**Recommended Amendments to the
2015 International Building Code**
North Central Texas Council of Governments Region

The following sections, paragraphs, and sentences of the *2015 International Building Code* are hereby amended as follows: Standard type is text from the IBC. Underlined type is text inserted. ~~Lined through type is deleted text from IBC.~~ A double asterisk (**) at the beginning of a section identifies an amendment carried over from the 2012 edition of the code and a triple asterisk (***) identifies a new or revised amendment with the 2015 code.

****Figure R602.6.1; delete the figure and insert the following figure:**

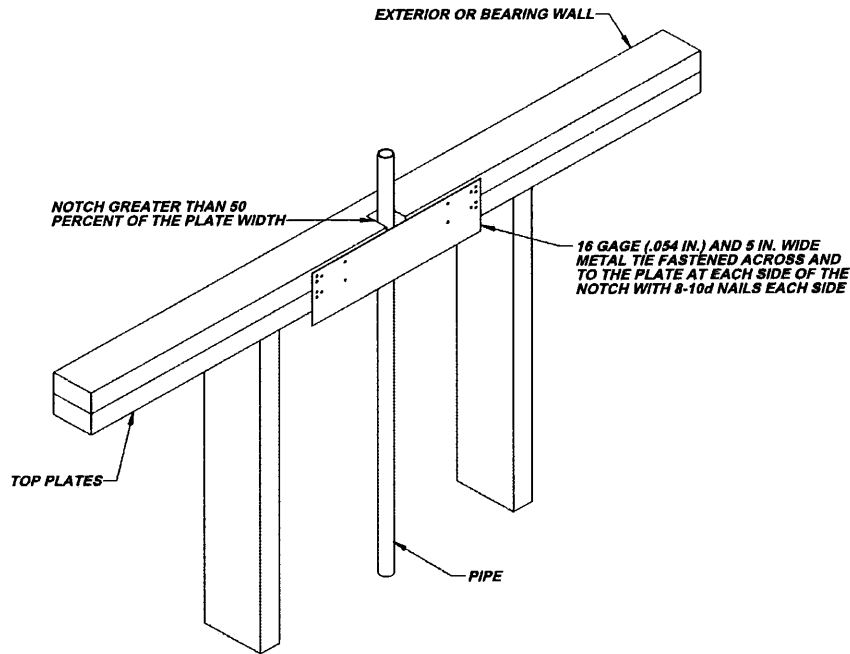
R602.6.1 Drilling and notching of top plate. When piping or ductwork is placed in or partly in an exterior wall or interior load-bearing wall, necessitating cutting, drilling or notching of the top plate by more than 50 percent of its width, a galvanized metal tie not less than 0.054 inch thick (1.37 mm) (16 Ga) and 4 ½ inches (38 mm) 5 inches (127 mm) wide shall be fastened across and to the plate at each side of the opening with not less than eight 10d (0.148 inch diameter) having a minimum length of 1 ½ inches (38 mm) at each side or equivalent. Fasteners will be offset to prevent splitting of the top plate material. The metal tie must extend a minimum of 6 inches past the opening. See figure R602.6.1. {remainder unchanged}

(Amendment to 2012 IRC carried forward to 2015 IRC also provides additional assurance of maintaining the integrity of the framing by spreading the nailing pattern.)
